Planning Commission Study Session

SUBJECT: UP14-04 SENNA AT SANTAN VILLAGE; A CONDITIONAL USE PERMIT FOR A MULTI-FAMILY MIXED USE DEVELOPMENT IN THE REGIONAL COMMERCIAL (RC) ZONING DISTRICT ON 16.34 ACRES OF REAL PROPERTY LOCATED WEST OF THE SOUTHWEST CORNER OF SANTAN VILLAGE PARKWAY AND RAY ROAD, IN THE REGIONAL COMMERCIAL (RC) ZONING DISTRICT.

UP14-04: Senna at SanTan Village Attachment 3 - Site Plan/Landscape Plan

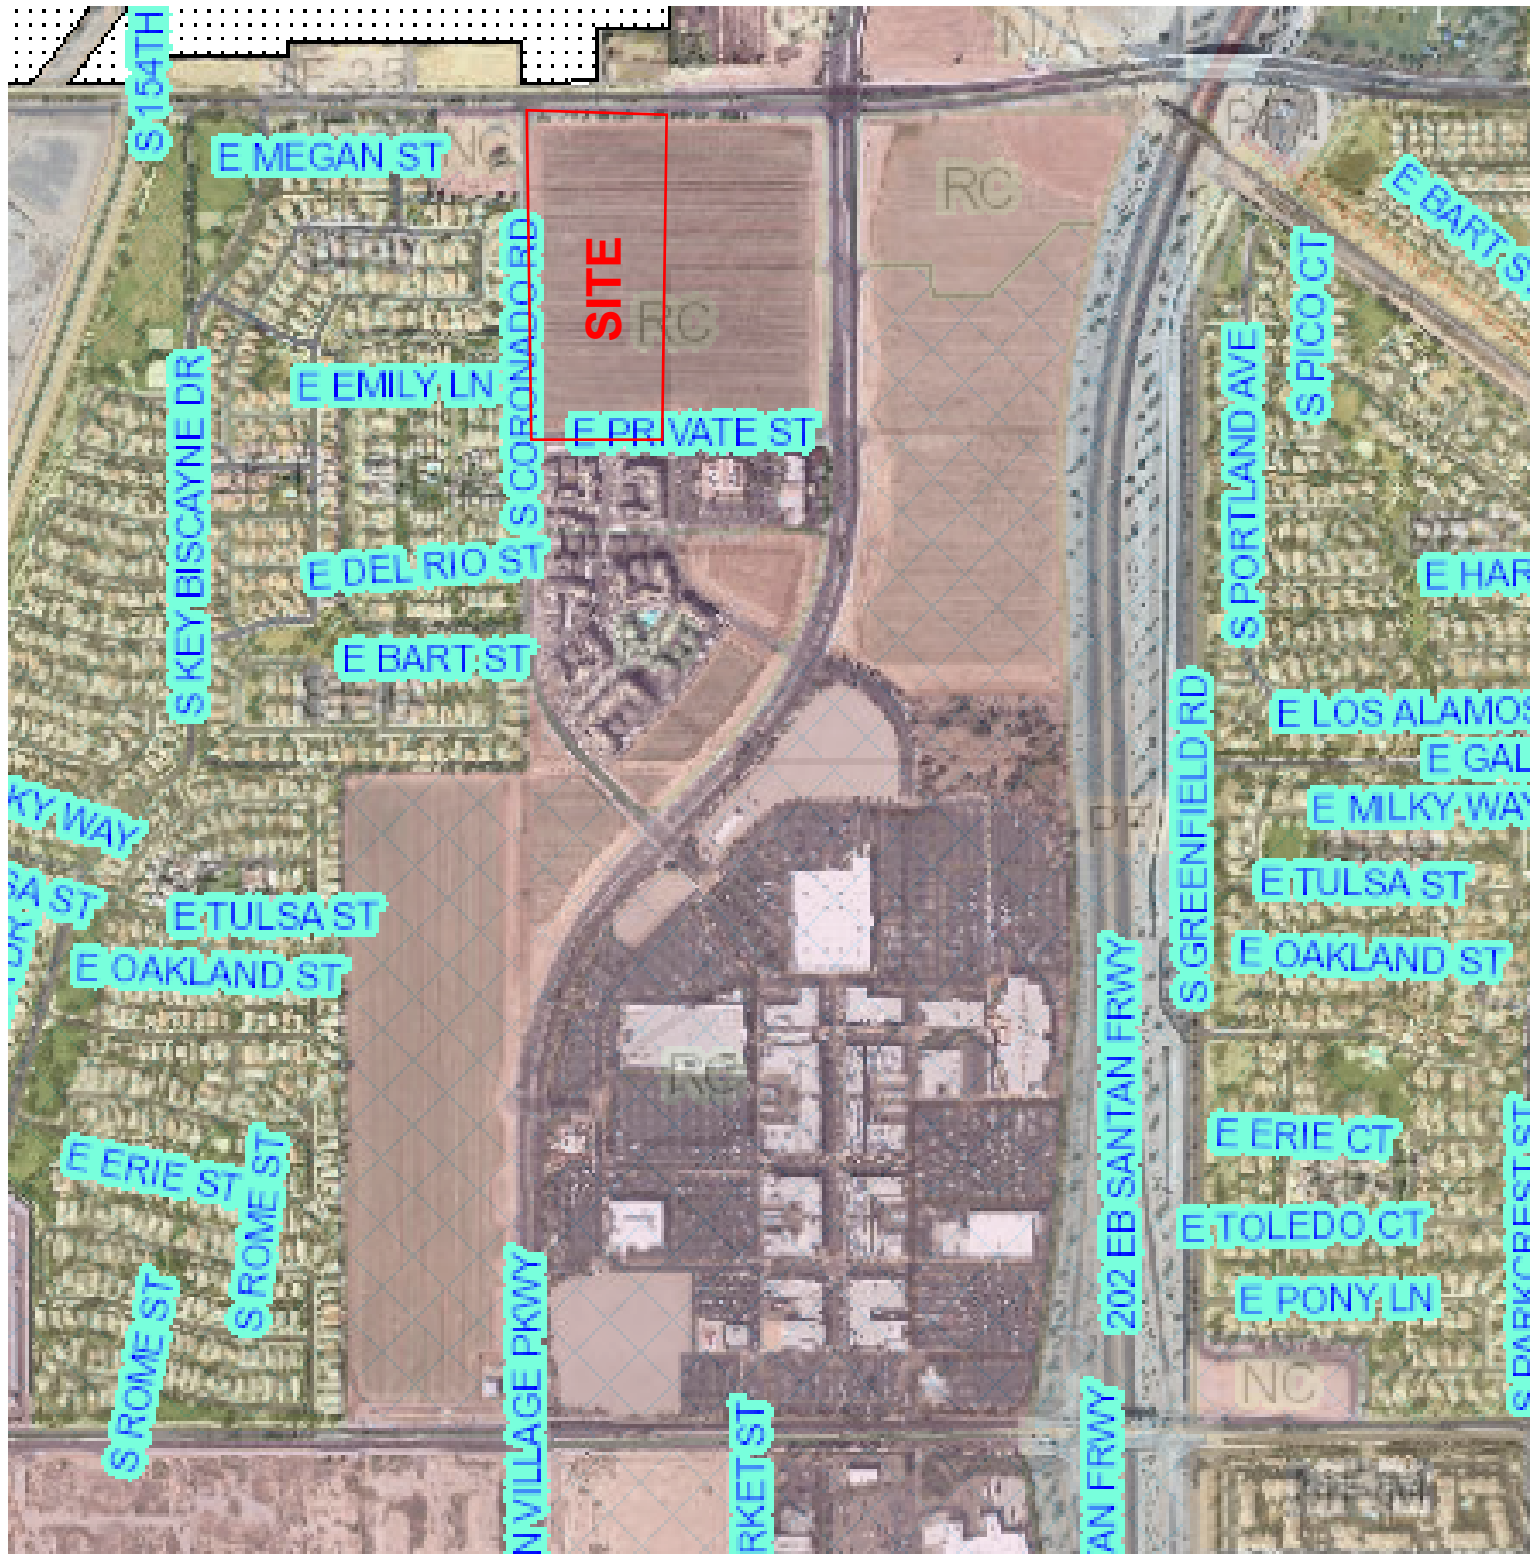
Internally, staff would like to see a more continuous sidewalk system that does not cross the internal project street back and forth. There are over 21 disconnected sidewalk locations within the project that require a pedestrian to cross the street, walk in the street or walk in the landscape.

As stated under Finding #6, staff believes that the sidewalk system within the project could be more contiguous. The sidewalks on the exterior of the project connect to surrounding sidewalks and lead to major streets and/or destinations. The plaza, architecture and the amenities are at acceptable pedestrian scale.
